# LOT 10 PARKER POINTE

LOT 10, PARKER POINTE FILING NO. 1  
 A PART SECTION 3, TOWNSHIP 7 SOUTH, RANGE 66 WEST OF THE SIXTH PRINCIPAL MERIDIAN  
 TOWN OF PARKER, COUNTY OF DOUGLAS, STATE OF COLORADO

## SITE PLAN

## EXTERIOR ELEVATIONS

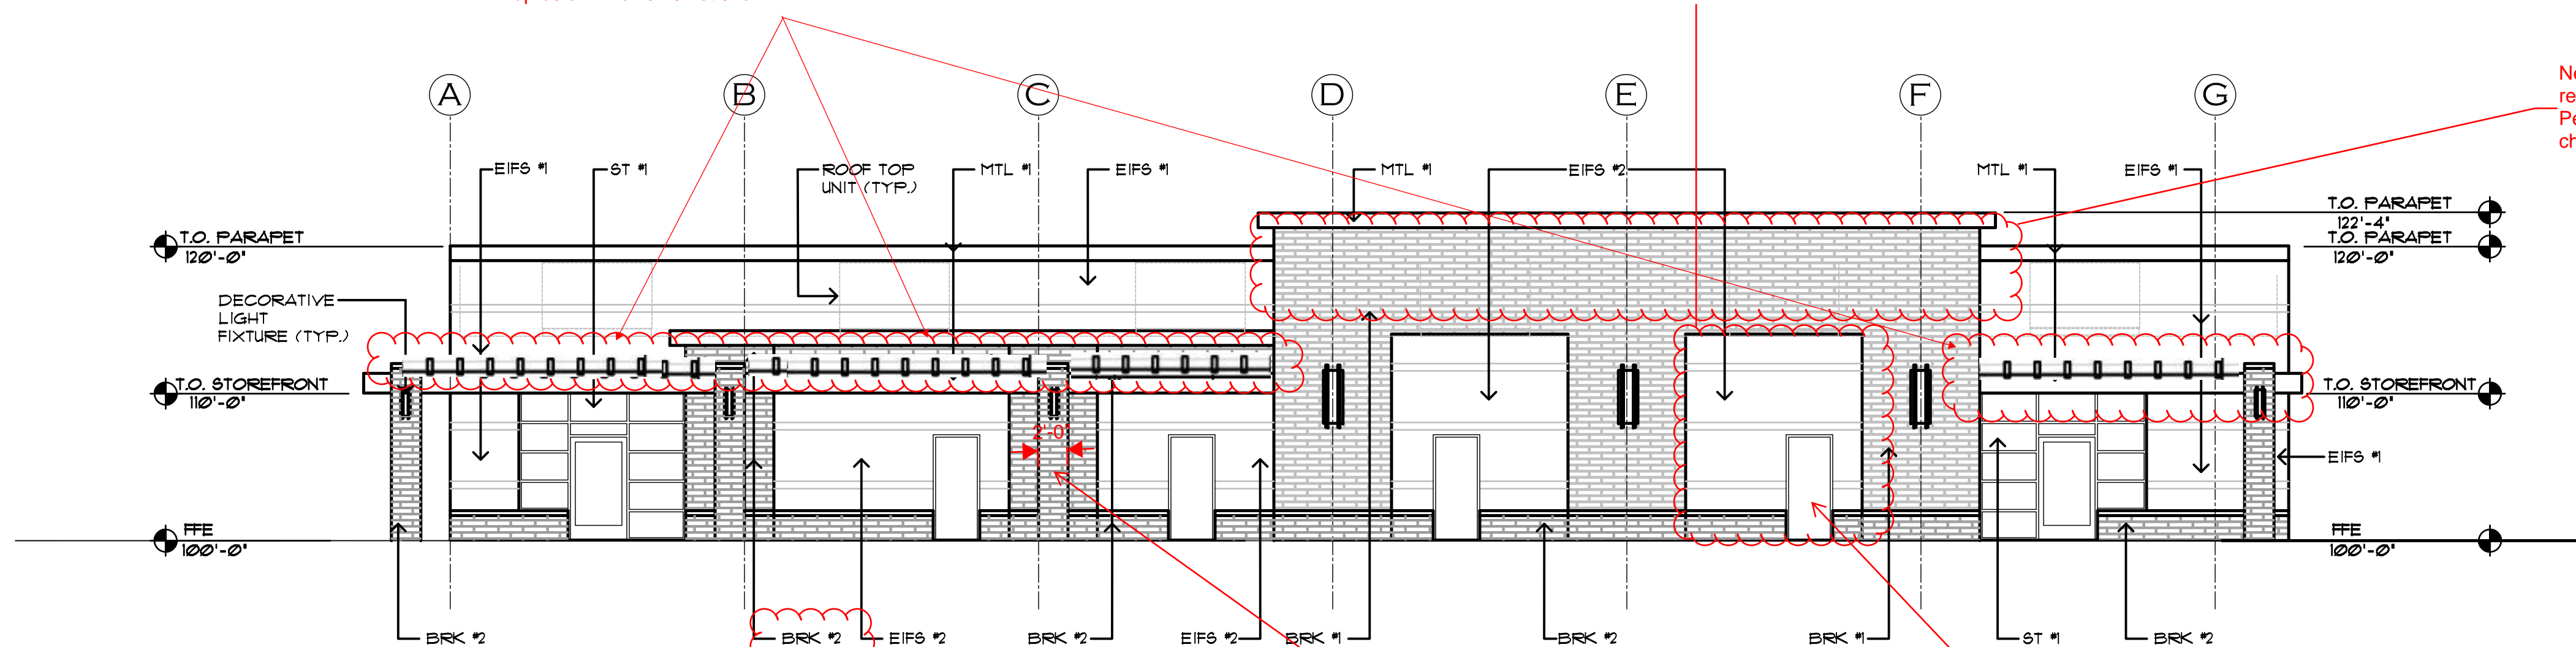
West elevation architecture reflects "back of house". Needs to reflect front or east elevation elements more closely. Faux trellis may be one way. Addition of exterior lighting may be another. Please review mock up below. Tower is not shown

EIFS is not a quality material. Consider other decorative treatment for areas where EIFS is shown, particularly at base and mid level.

Improve plane change per note on sheet 8 of 12.

Should this be brick 1?

Proposed projections do not meet the requirements in the Architectural Concepts of the design guidelines submitted for this shopping center relative to plane changes under architectural massing and scale. Please see highlighted design guidelines. Additionally, no timbers have been used in this design as is encouraged in the design guidelines, unless the patio trellis is constructed of timbers. No material is identified for the trellis in the exterior materials table.

Please clarify door material and detail. These doors face Parker Rd and should reflect "front of house" architectural detail.

Need some horizontal relief in this area. Perhaps a material change or

## SITE PHOTOMETRIC PLAN

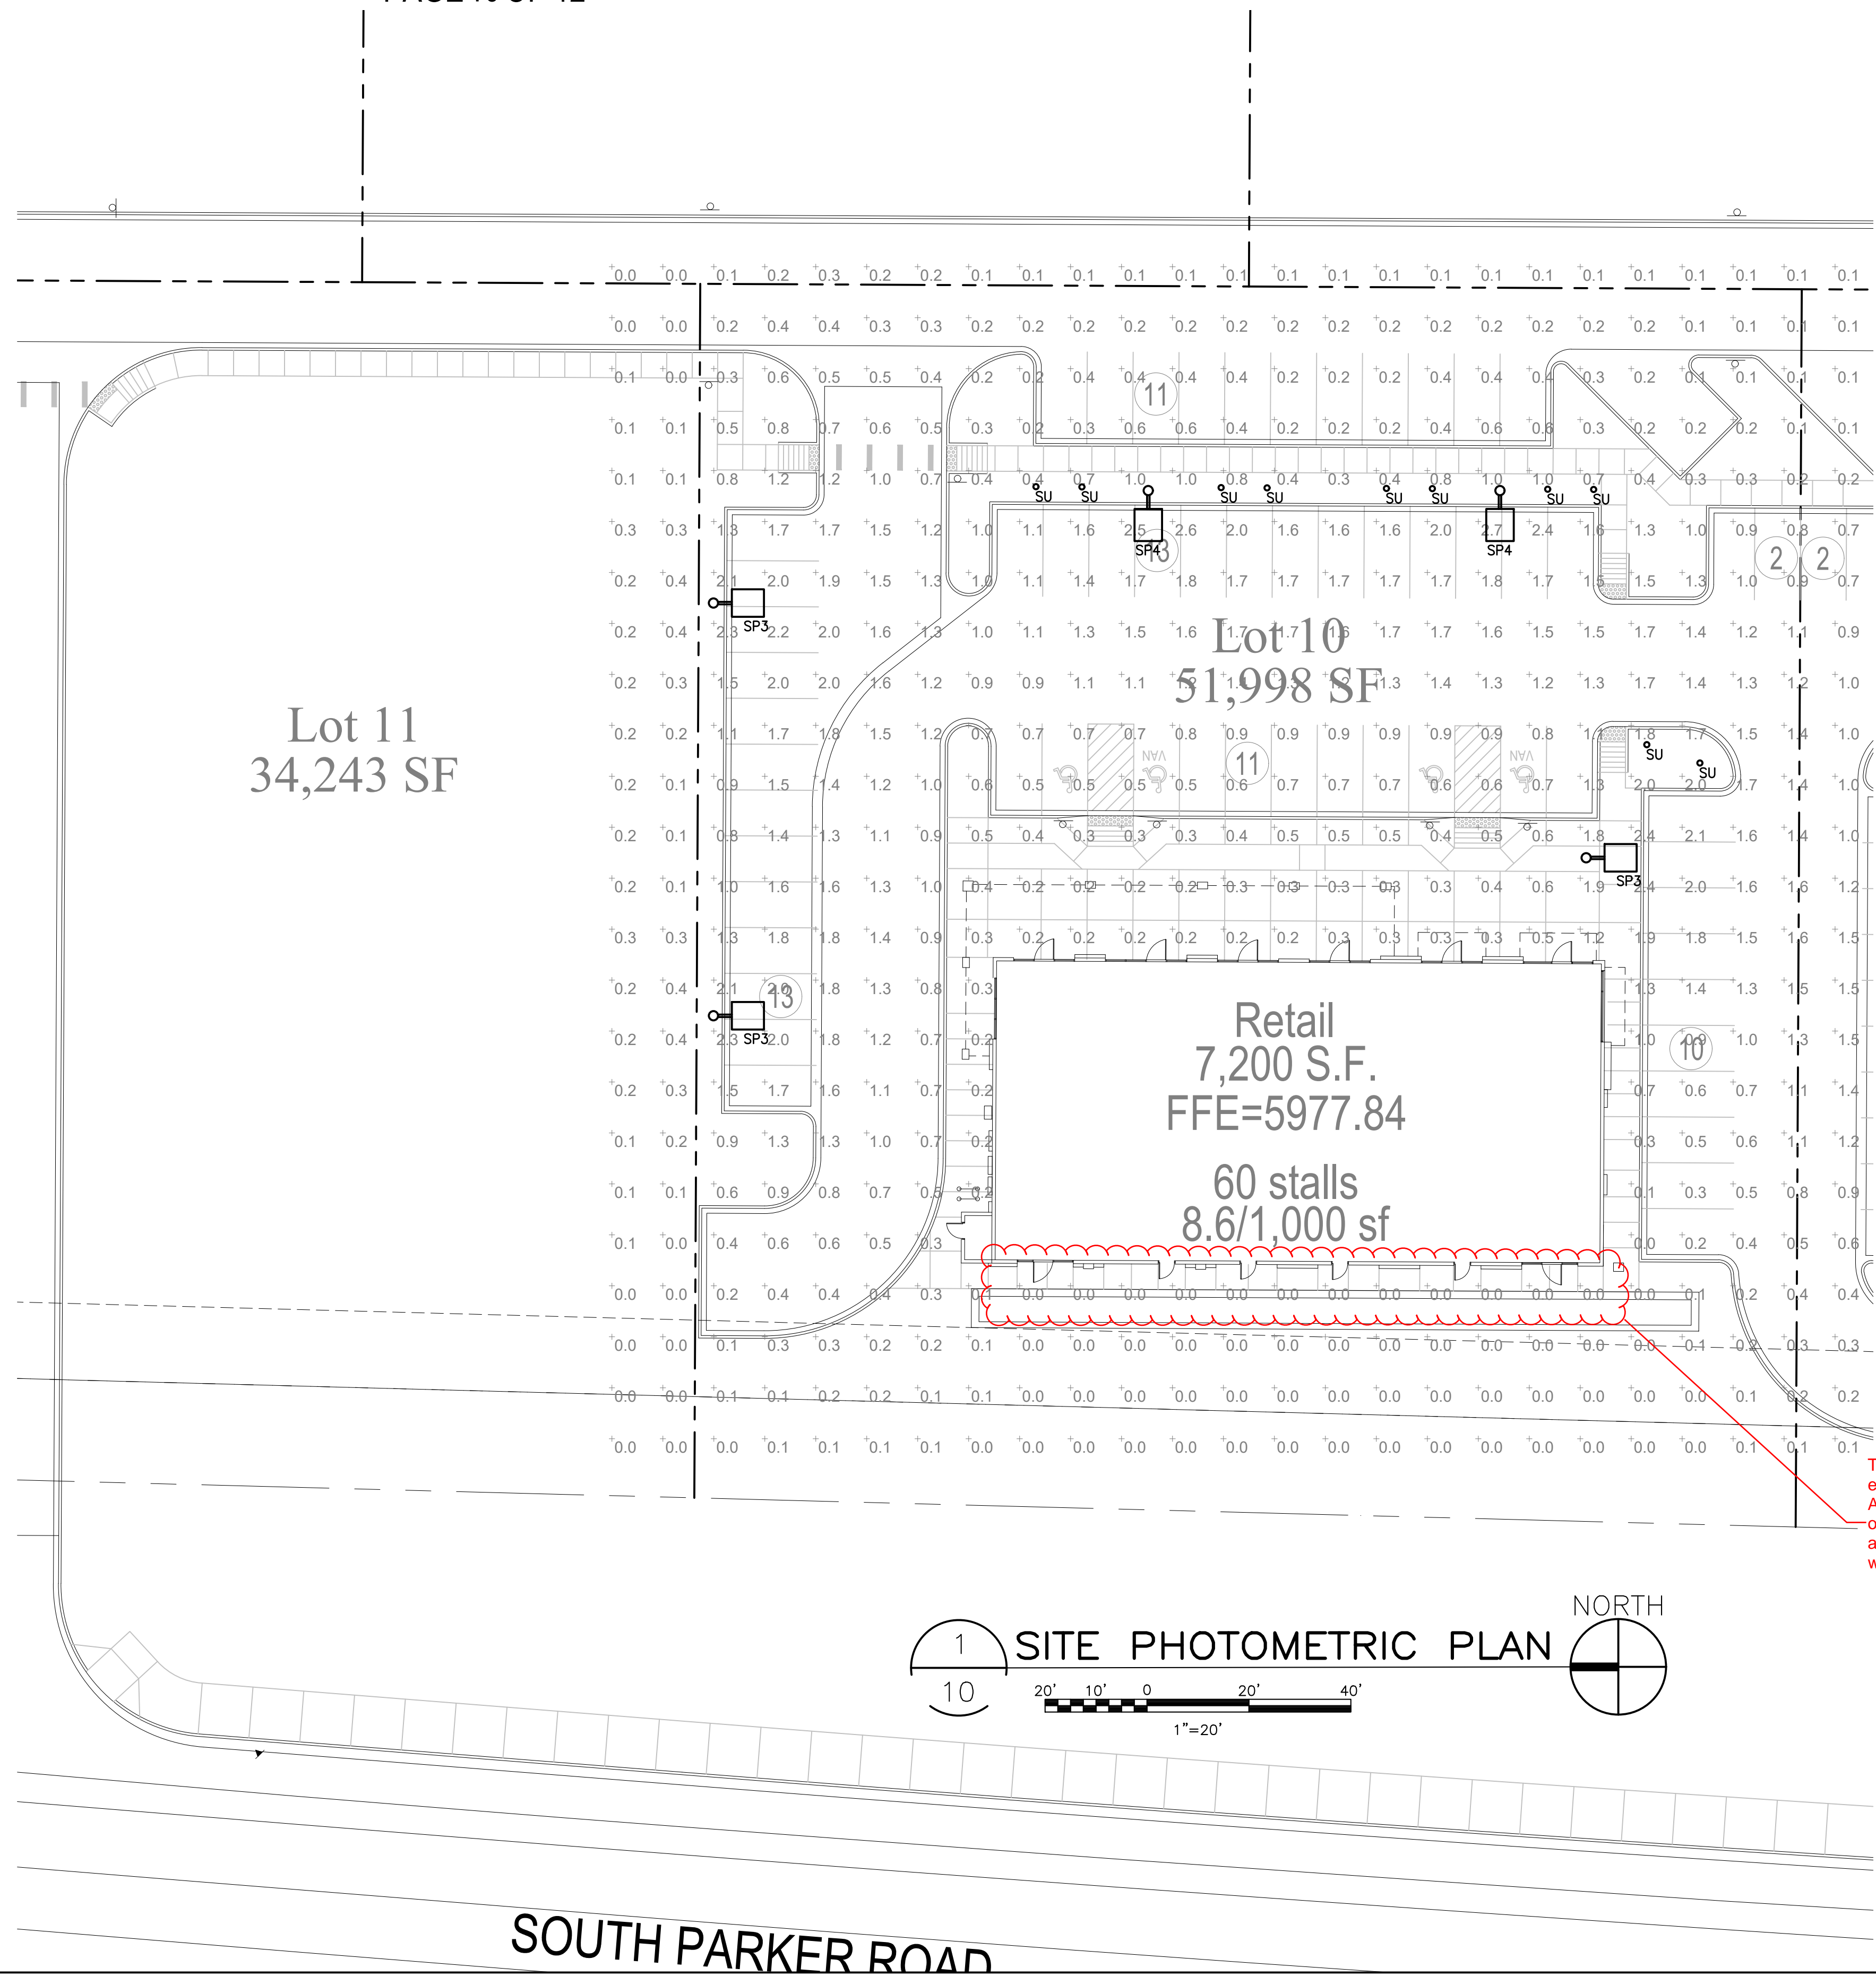
Must use positive number, please recalculate.

Decorative wall lighting has not been shown and no cut sheet has been provided.

There are access doors on this elevation. Additional lighting is needed. Additional lighting has been suggested on the mock up on 9 of 12 though another idea that would meet the intent would be considered.

## SITE LIGHTING DETAILS

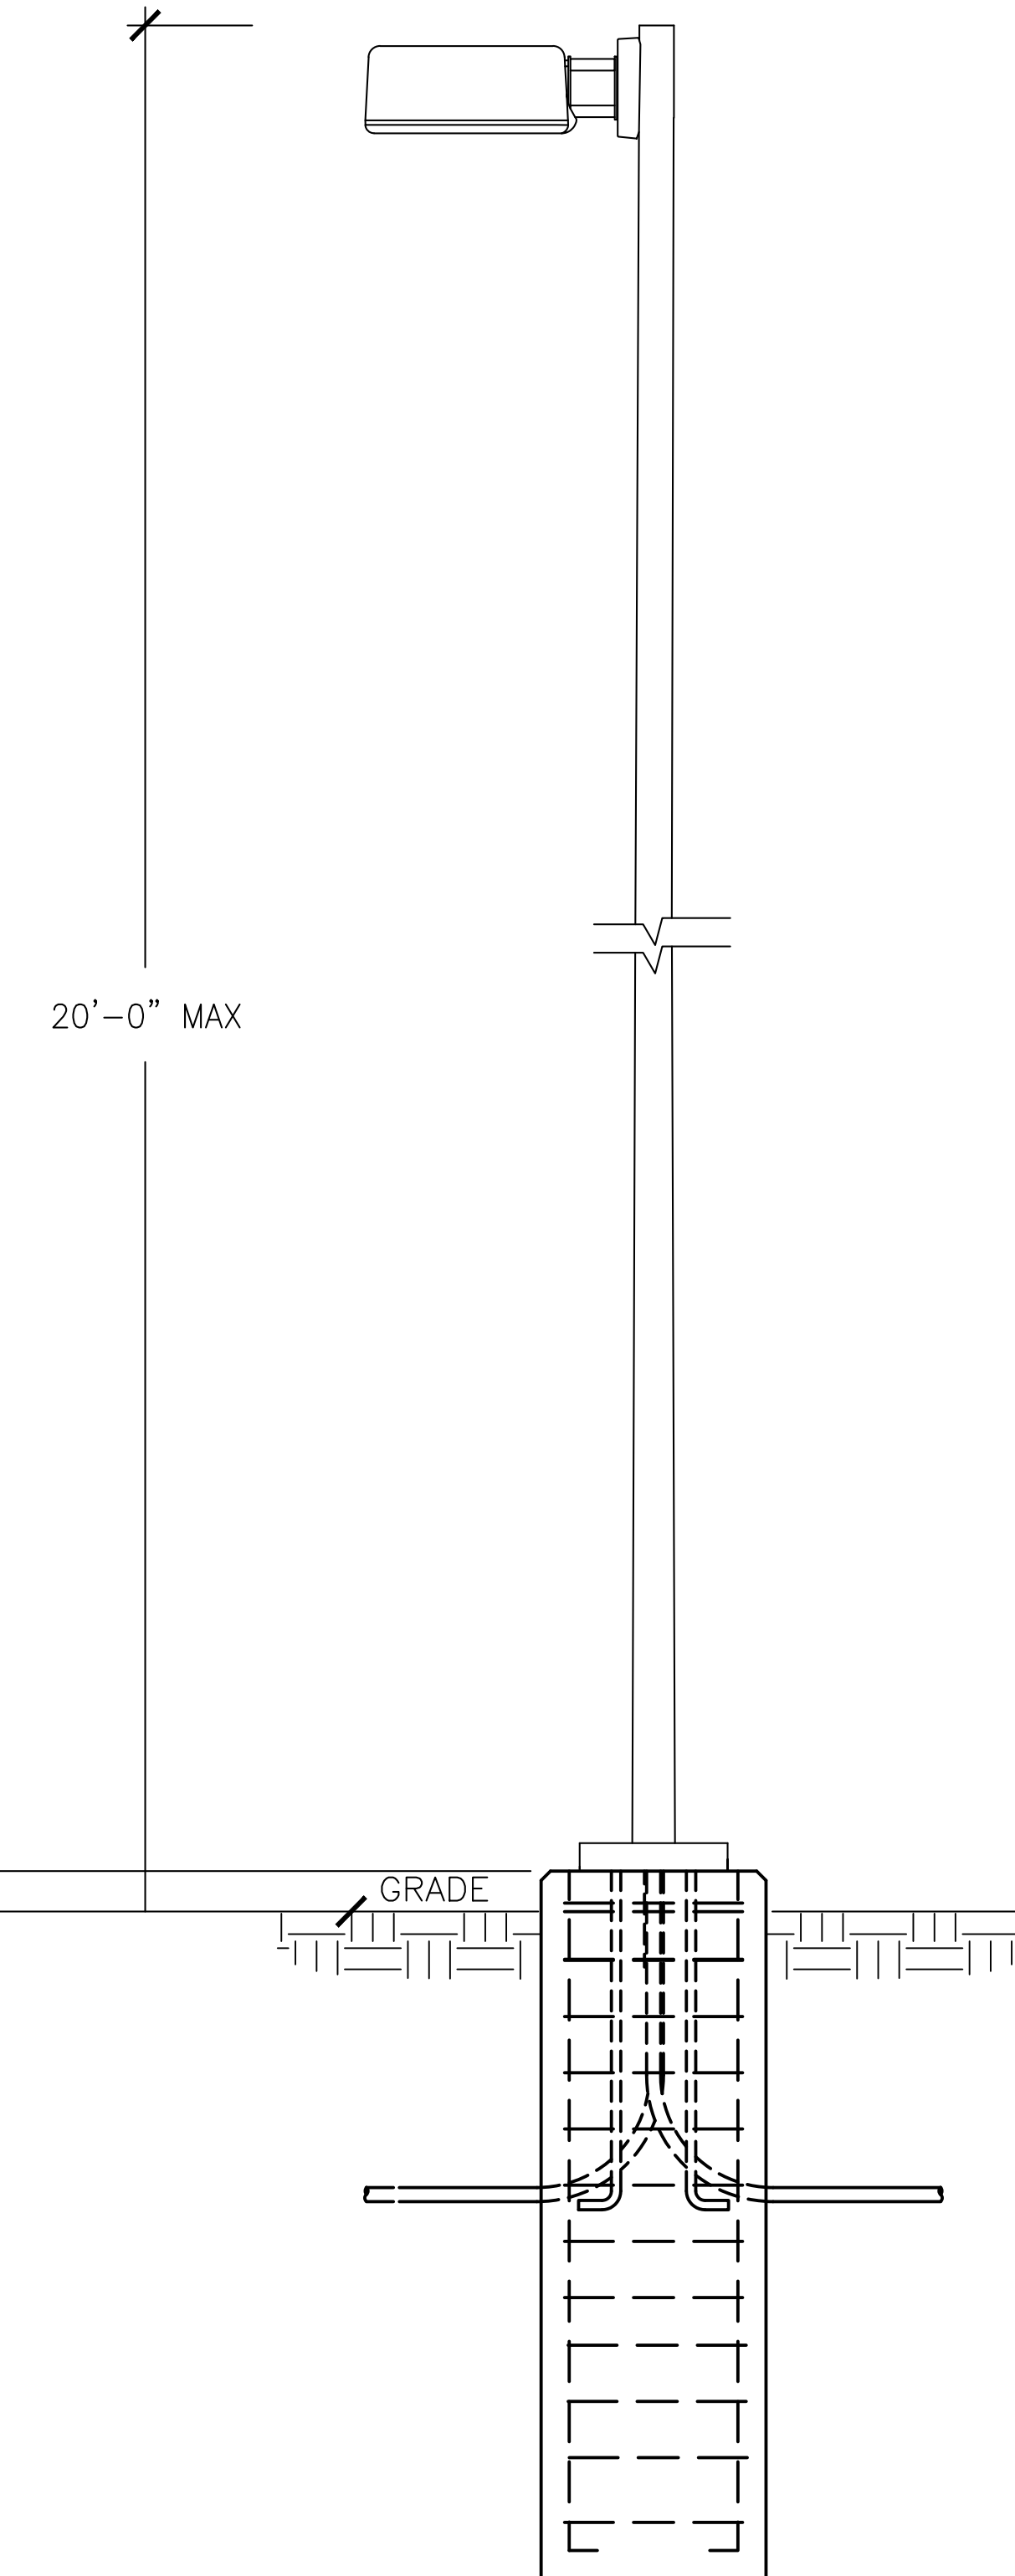
Missing fixtures and no quantities provided.
